## Report to Planning and Environment Committee

**Subject:** 2492222 Ontario Inc.  
536-542 Windermere Road

**Public Participation Meeting on: July 13, 2020**

# Site Plan

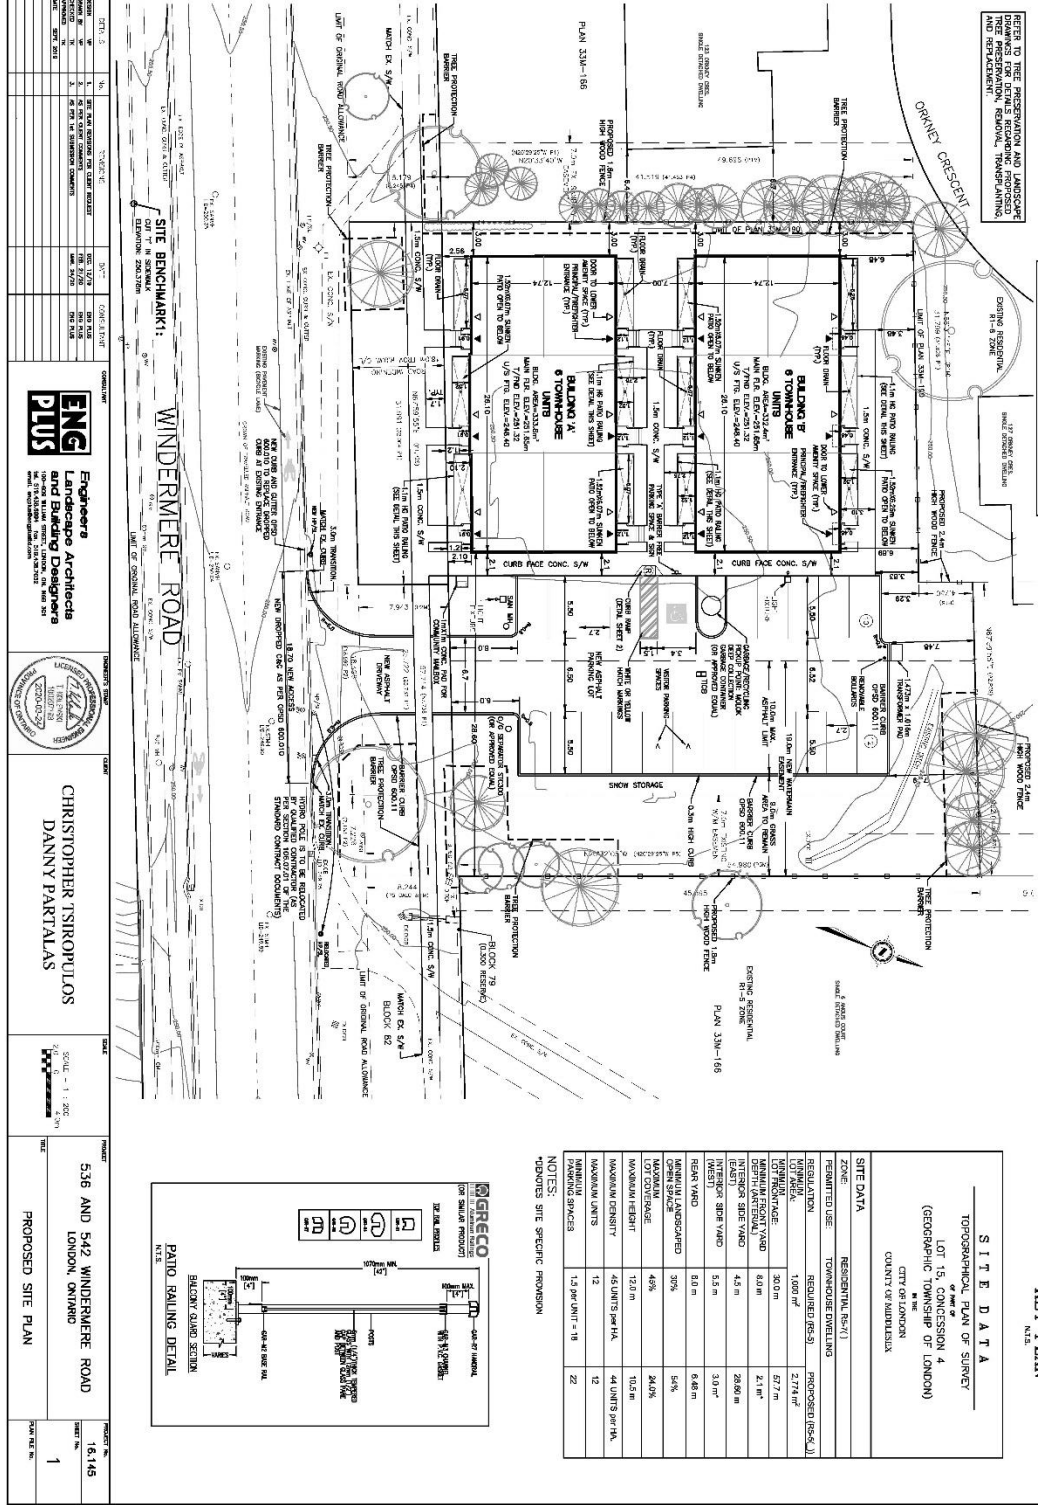
- The Site Plan Approval Authority will be not be able to issue approval until the applicant is able to address outstanding issues including:
  - Provision of a Site Plan with provision of amenity space which are at-grade and sufficiently separated from parking in accordance with the Site Plan Control By-law.

- The additional 4 parking spaces proposed be removed to provide communal amenity space. Consideration to removing the parking spaces that would result in headlights between the buildings (into their access) and introducing low landscape screening (max 0.9m) to reduce light and exhaust impacts.

- The Site Plan Control By-law requires a space of 8.0m between habitable walls. As a reduction is considered provide reasoning (such as window offset, screening).

- The ponding associated with the west and north property boundaries appears to exceed City Standards for acceptable ponding. Elevations shown on the grading plan would indicate ponding reaches a depth of nearly 900mm; City Standards only allow for a maximum of 450mm. The consultant should review the grading plan for options to reduce ponding under a 100 year storm event and provide for the safe conveyance of flows. i.e. a swale directed southwards, ensuring the public sidewalk is not affected.

- The ponding areas noted above shall be self-contained within the subject site during the 100 year storm event. Grading shall be adjusted accordingly.

- Separate services will need to be provided for both sanitary and water for the townhouse units. Unless there is a common space, each townhouse unit is to have a separate sanitary service leaving the unit (horizontal sanitary from one unit cannot be installed underneath another unit and leave building as a single sanitary service (OBC 7.1.5.4.(4)). Per Ontario Building Code (OBC), the water service should not run through another unit. One meter fronting each residential unit will need to be installed.

Side Elevation

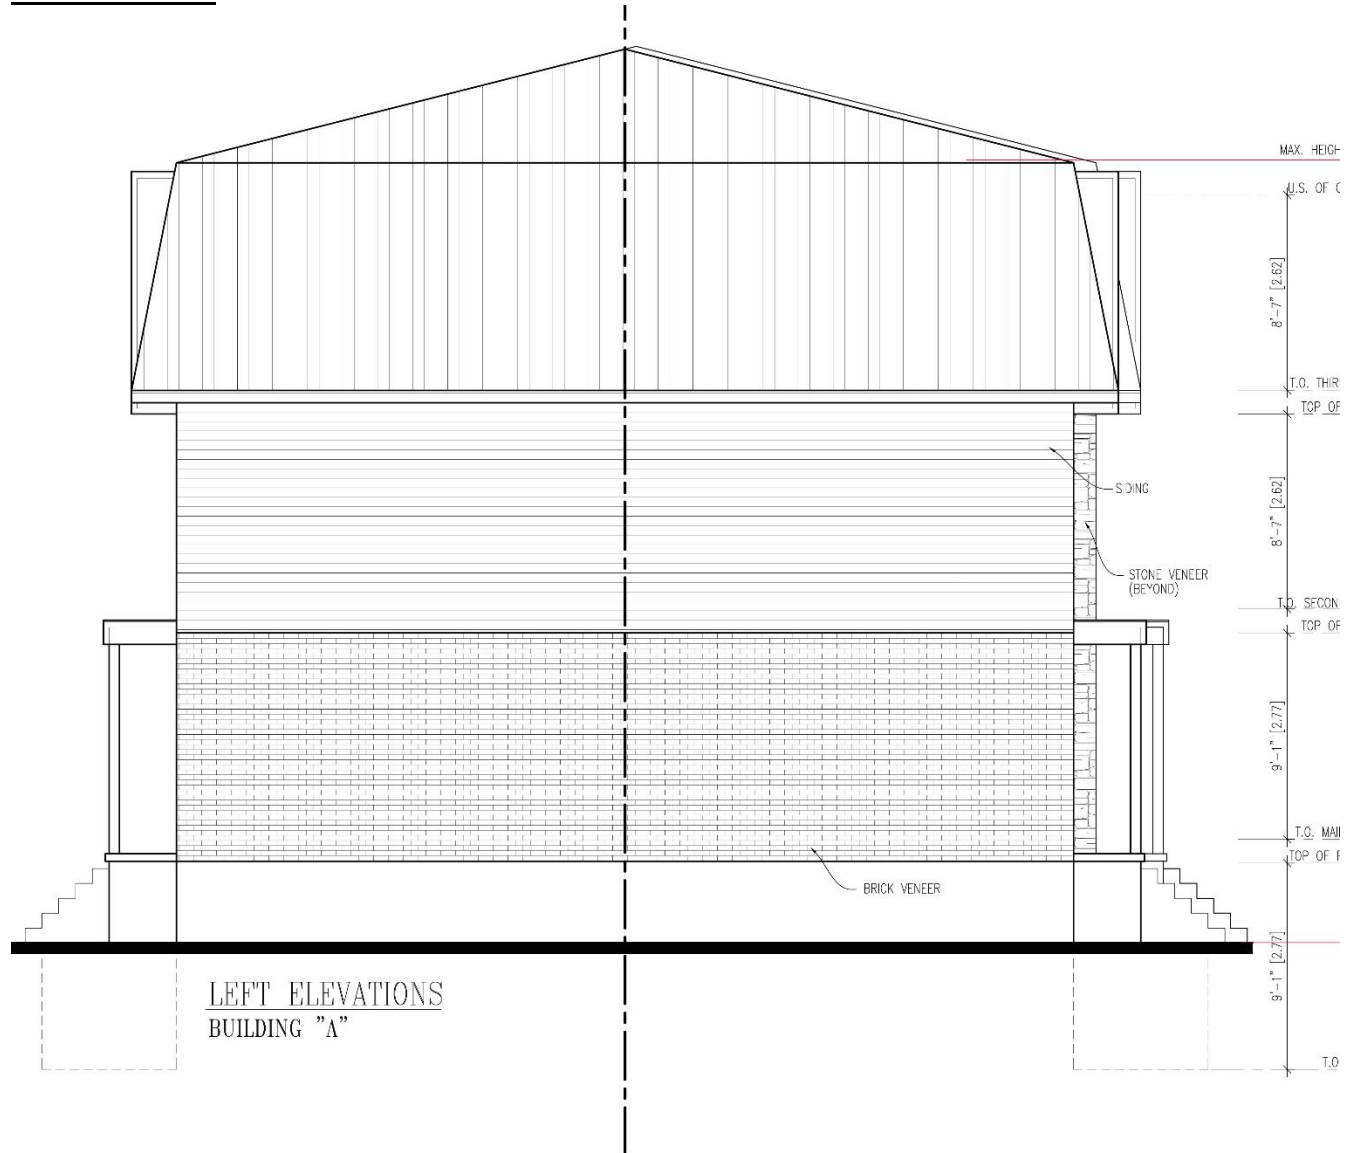
- Elevations that have provided for articulation and openings (notably the east elevation).
- Photometric – consider a lighting approach that provides some lighting between the buildings comprised in the development. This lighting should be designed to illuminate the space but not be aimed directly towards windows, particularly bedrooms.

- In keeping with the recommendation of the UDPRP, provide windows on the east elevations of the proposed buildings as these elevations are highly visible from the Windermere Road frontage. Including windows on these facades will also provide for eyes on the parking area and the amenity area to the east of the parking lot. (UDPRP memo is provided as appendix D)

- Provide spatial separation calculations to determine the maximum unprotected openings per OBC to confirm proposed elevations can be built as shown and separated.

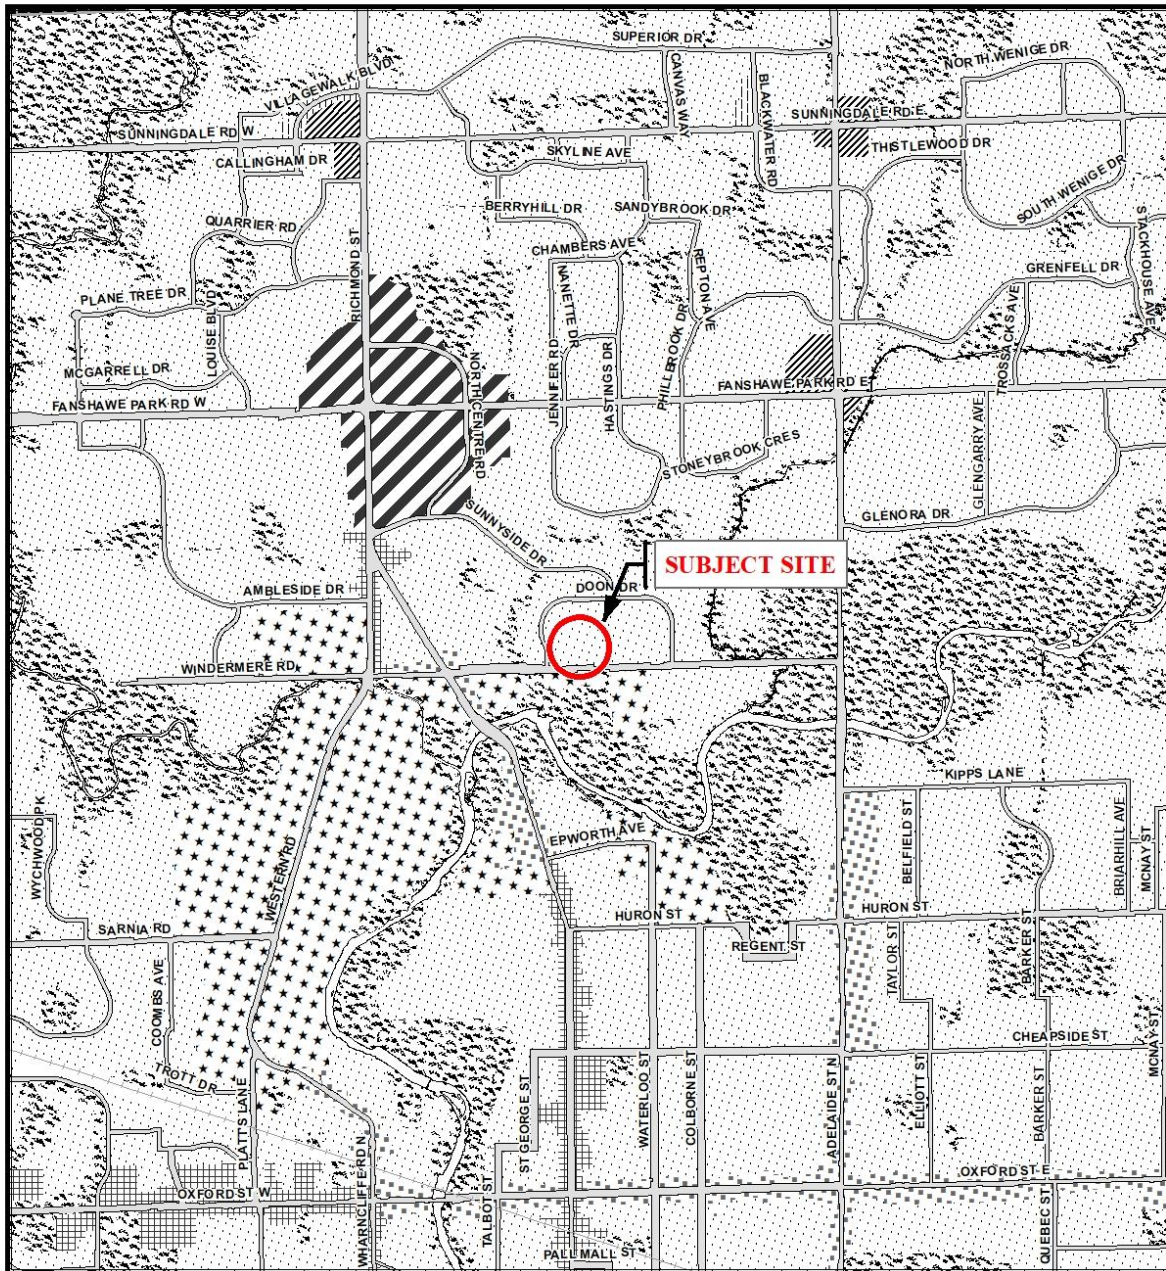
First, looking at the landscape plan it shows 2 cedar shrubs planted side by side at the southwest corner of building A. I believe the developer assumes these cedars will prevent pedestrian traffic from cutting through the west side of building A to access building B. In my opinion these cedars will not deter those wanting to take a short cut. A better solution to restricting pedestrian access would be a fence or some kind of secure barrier running from the southwest corner of building A to the existing fence that borders my property. The issue of privacy, security and safety must be taken into account.

The second concern has to deal with the height of the wooden fence that runs along the west side of 536 Windermere Rd. The developer is planning to install a fence 1.8 m high on the west and a 2.4 m. fence to the north side along 127 Orkney Cr ([REDACTED] property). The 1.8 m fence would not prevent occupants from climbing it to access Orkney Crescent. It would make sense for privacy, security and aesthetics to make the fence a consistent height of 2.4 m and to discourage those from attempting to climb over it.
